UNITED STATES PATENT AND TRADEMARK OFFICE

10/532,552

Office Action Summary

DETAILED ACTION

F I G . 5 .

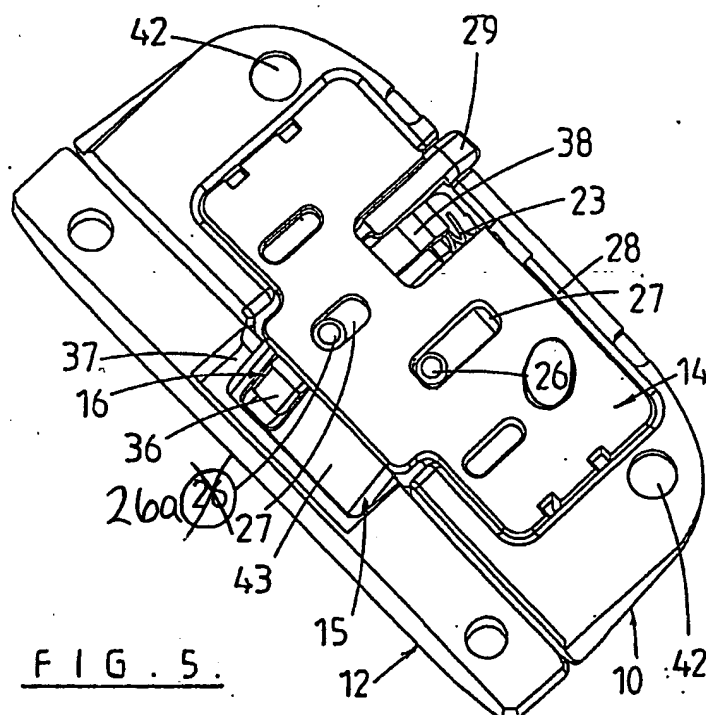
2. The original objection to the drawings still stands because in the original drawings filed on April 22, 2005 reference character "26" has been used to designate both a first lug and a second lug in Figure 5, and Figure 12 does not include reference character 56, as discussed on page 14, line 9 of the specification. Corrections to the original drawings filed, specifically Figures 5 and 12, can be found in Drawing Attachments 1 and 2. Corrected drawing sheets in compliance with 37 CFR 1.121(d) are required in reply to the Office action to avoid abandonment of the application. Any amended replacement drawing sheet should include all of the figures appearing on the immediate prior version of the sheet, even if only one figure is being amended. The figure or figure number of an amended drawing should not be labeled as "amended." If a drawing figure is to be canceled, the appropriate figure must be removed from the replacement sheet, and where necessary, the remaining figures must be renumbered and appropriate changes made to the brief description of the several views of the drawings for consistency. Additional replacement sheets may be necessary to show the renumbering of the remaining figures. Each drawing sheet submitted after the filing date of an application must be labeled in the top margin as either "Replacement Sheet" or

FIG. 4.

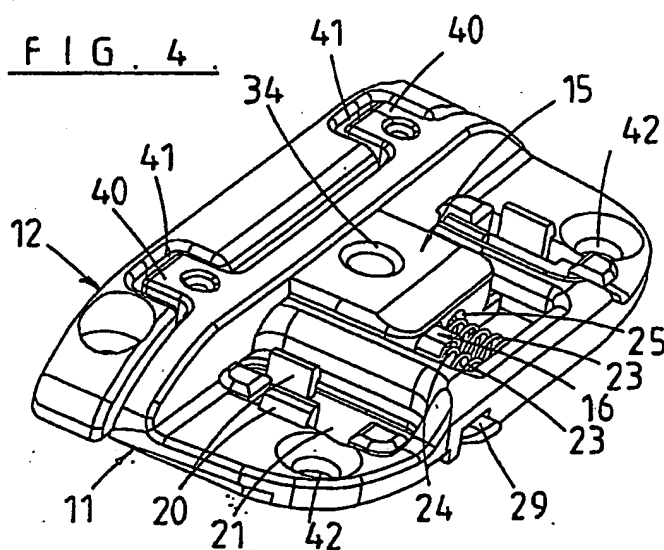
10. After further review of the application, the drawings are objected to because the interaction between the primary bolt and the secondary bolt when incorporating the trigger clip for retaining the primary bolt is not clear from the drawings. Specifically, it is unclear from the drawings how the primary bolt is retained by the trigger clip, since it seems from the drawings that the secondary clip is in line with the trigger clip not an engaging portion of the primary bolt. Corrected drawing sheets in compliance with 37 CFR 1.121(d) are required in reply to the Office action to avoid abandonment of the application. Any amended replacement drawing sheet should include all of the figures appearing on the immediate prior version of the sheet, even if only one figure is being amended. The figure or figure number of an amended drawing should not be labeled as “amended.” If a drawing figure is to be canceled, the appropriate figure must be removed from the replacement sheet, and where necessary, the remaining figures must
